B 0.3 Elektrik, Batterie, Lima

Gruppe	Nummer	Version
B 0.3	smc-07-86 vwm-07-06	01

Engine wirings by Durapart Industries AS

siehe -Pfeil
Abb. 1

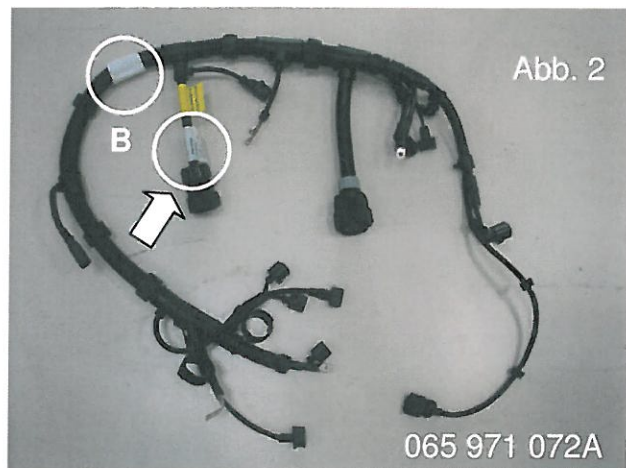
In any case replace the wiring with part number 065 971 074A (arrow Fig. 1).

siehe Pfeil
Abb. 2

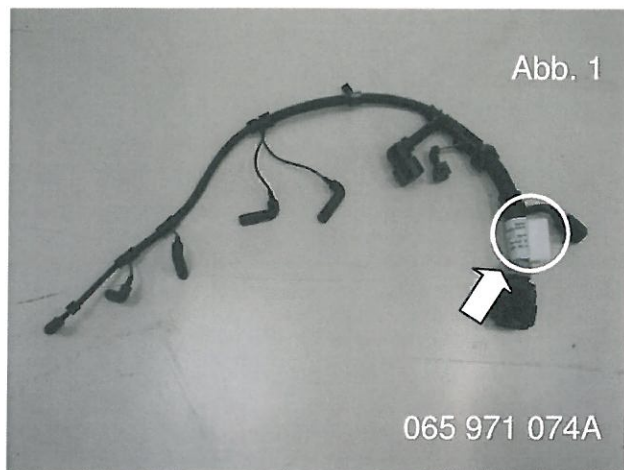
In addition replace the wiring with part number 065 971 072A (Fig. 2), if it bears the country-specific identification „Lithuania“.

You will find the part number and country-specific identification on the label marked with an arrow in Fig. 2.

The wiring with part number 065 971 072A and country-specific identification „Lithuania“ must **not** be replaced, if it is already tagged „100% O.K.“ (see identification mark – B - Fig. 2).
